A.R.M. (USA) Super Shot service bulletin

Bulletin No: SB20180221
Release Date: February 21, 2018
Effective Date: March 1, 2018
Supersedes: N/A
Completion Date: May 30, 2018
Page: 1 of 7

SERVICE BULLETIN

Mandatory installation of secondary locking mechanism to prevent passenger seats from dislodging in the event seat attachment bolts are not installed.

Round Carriage Frames Only...

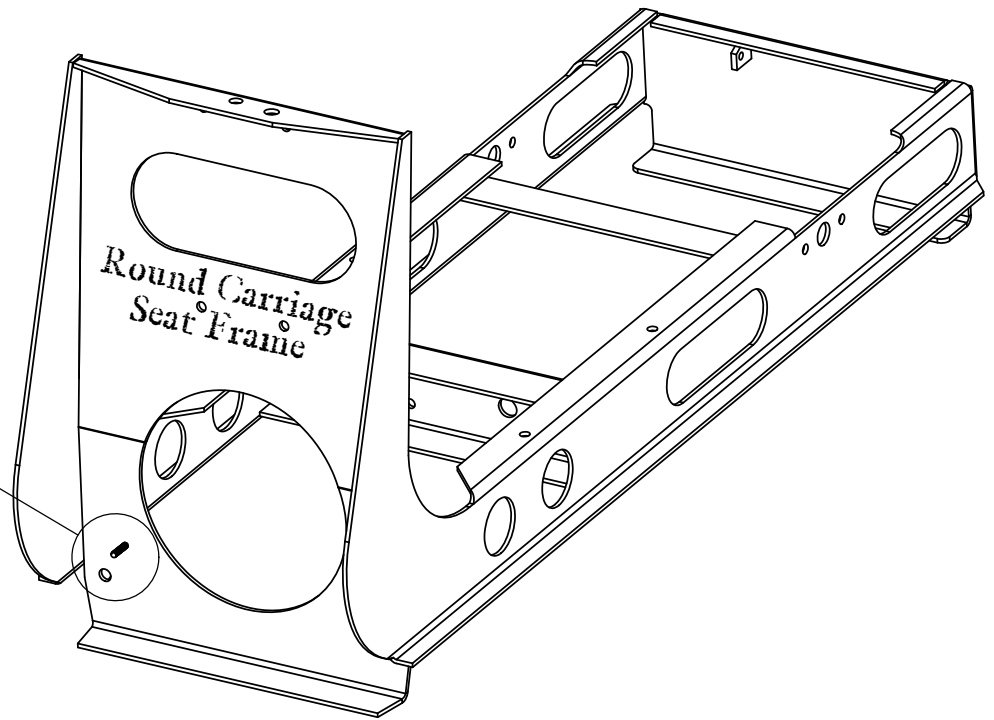
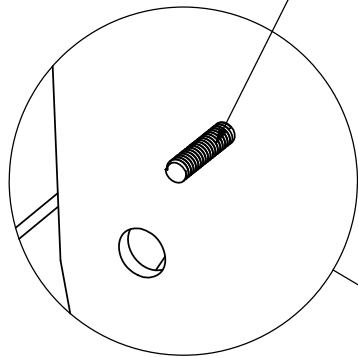
- Remove Threaded Stud Supporting Electrical Wires.
- Grind Flush And Apply Primer/Paint

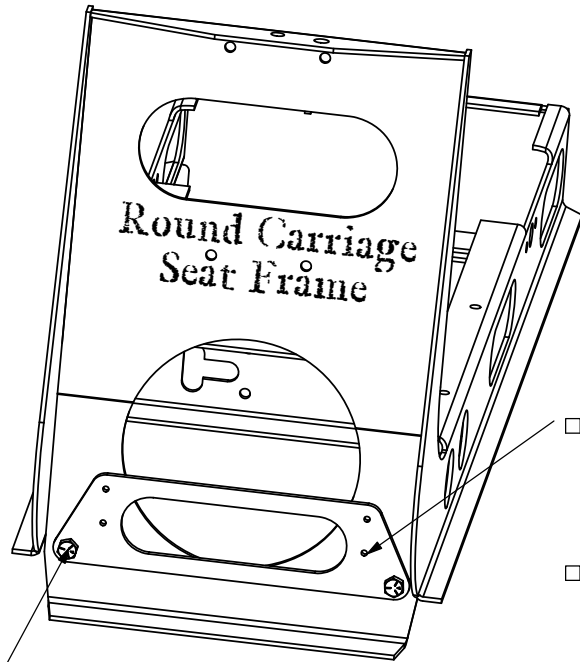
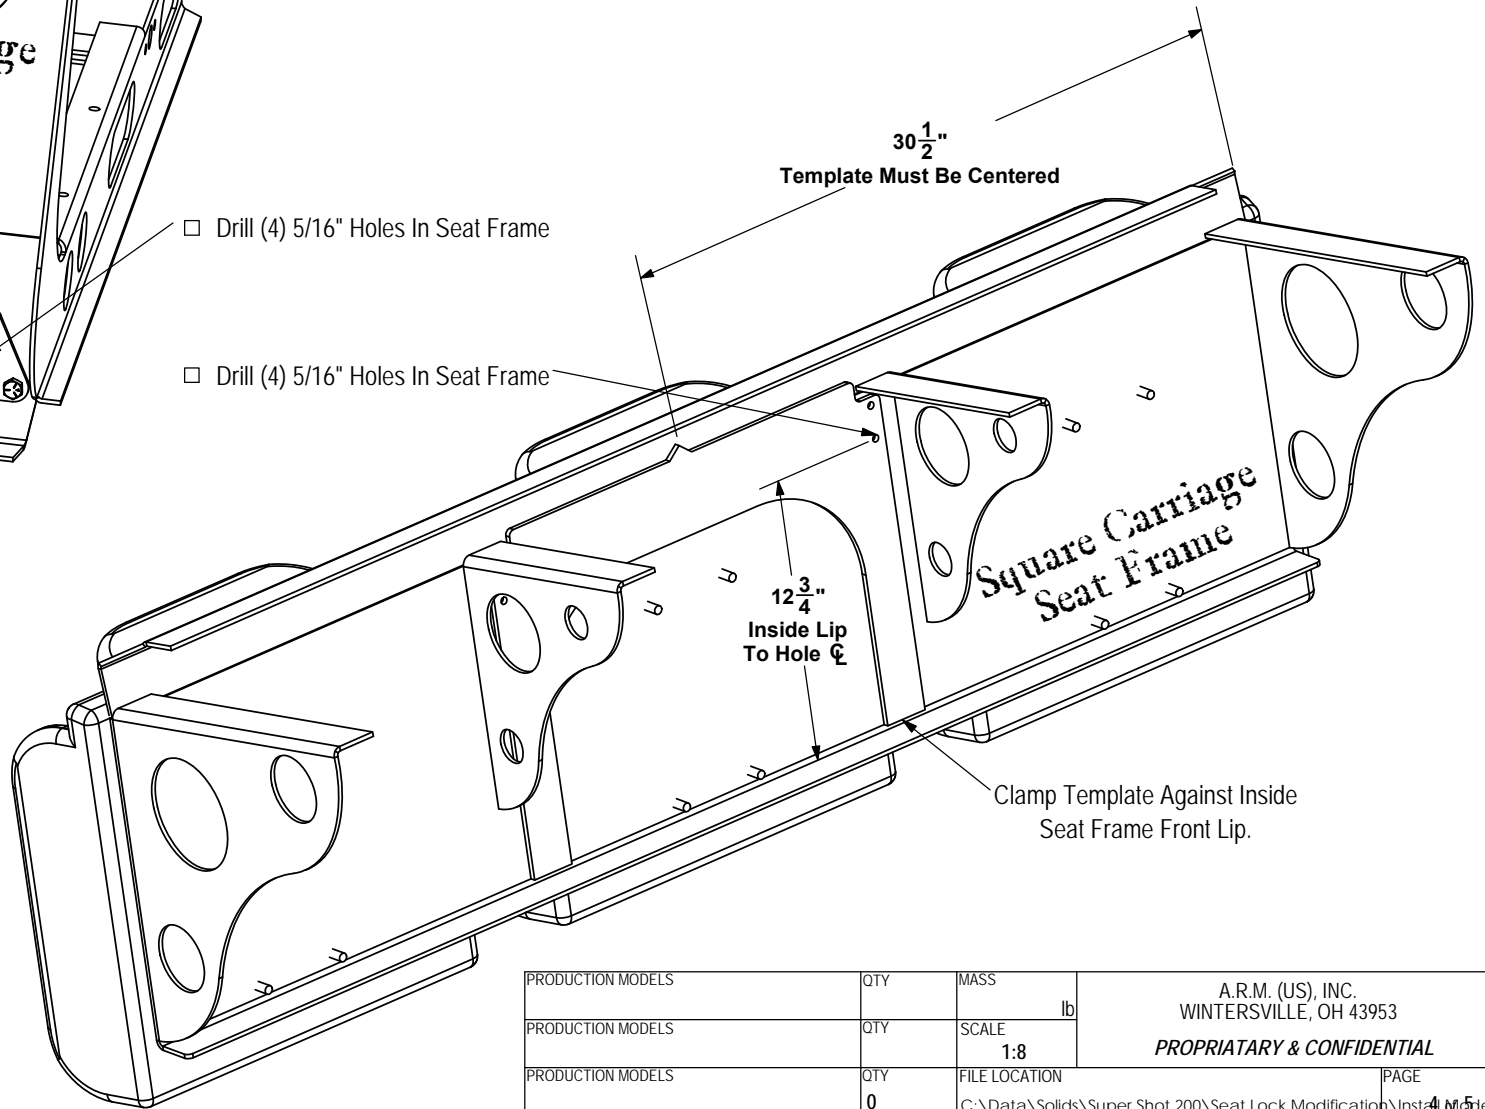
□ Bolt Drilling Template In Place Using Existing Seat Bolt Holes.

□ Drill (4) 5/16" Holes In Seat Frame

□ Drill (4) 5/16" Holes In Seat Frame

30 $\frac{1}{2}$ "
Template Must Be Centered

12 $\frac{3}{4}$ "
Inside Lip To Hole ϕ

Clamp Template Against Inside Seat Frame Front Lip.

Round Carriage
Seat Frame

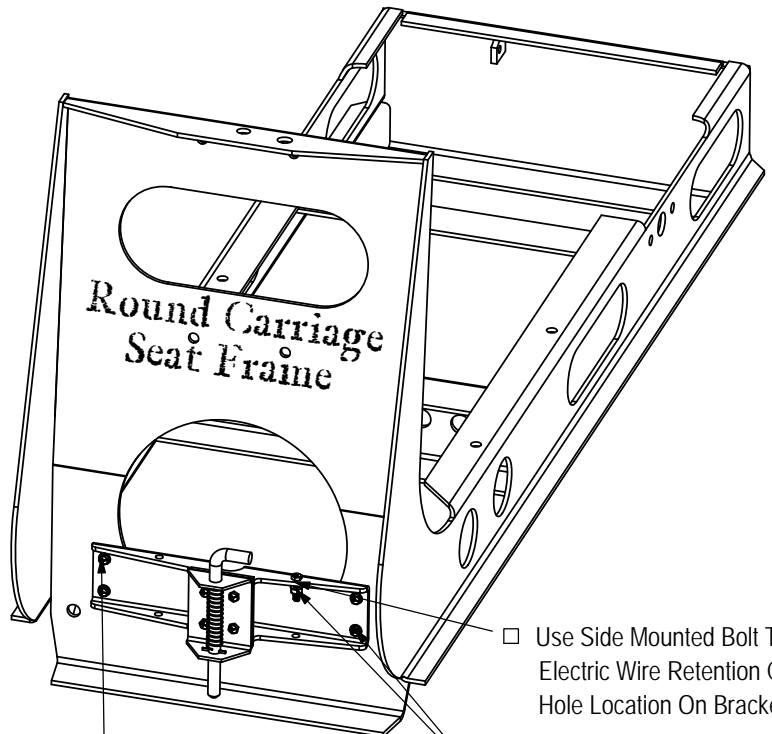
- Use Side Mounted Bolt To Reattach Electric Wire Retention Clip. Use Suitable Hole Location On Bracket.
- Torque 1/4" GR5 Bolts To 6.3 Ft Lbs.

□ Bolt Latch Assembly To Frame Using Newly Drilled Holes.

Square Carriage Seat Frame

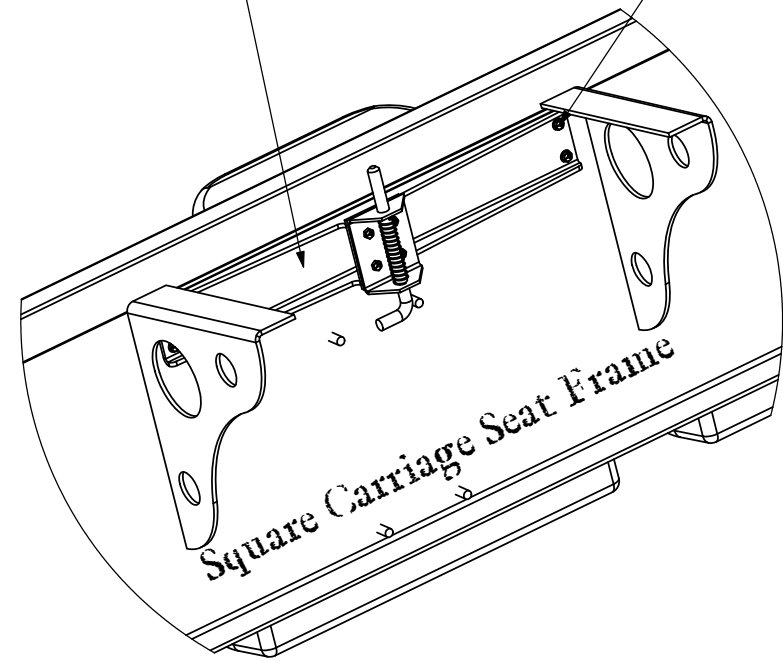
- Bolt Latch Assembly To Frame Using Newly Drilled Holes.
- Torque 1/4" GR5 Bolts To 6.3 Ft Lbs/
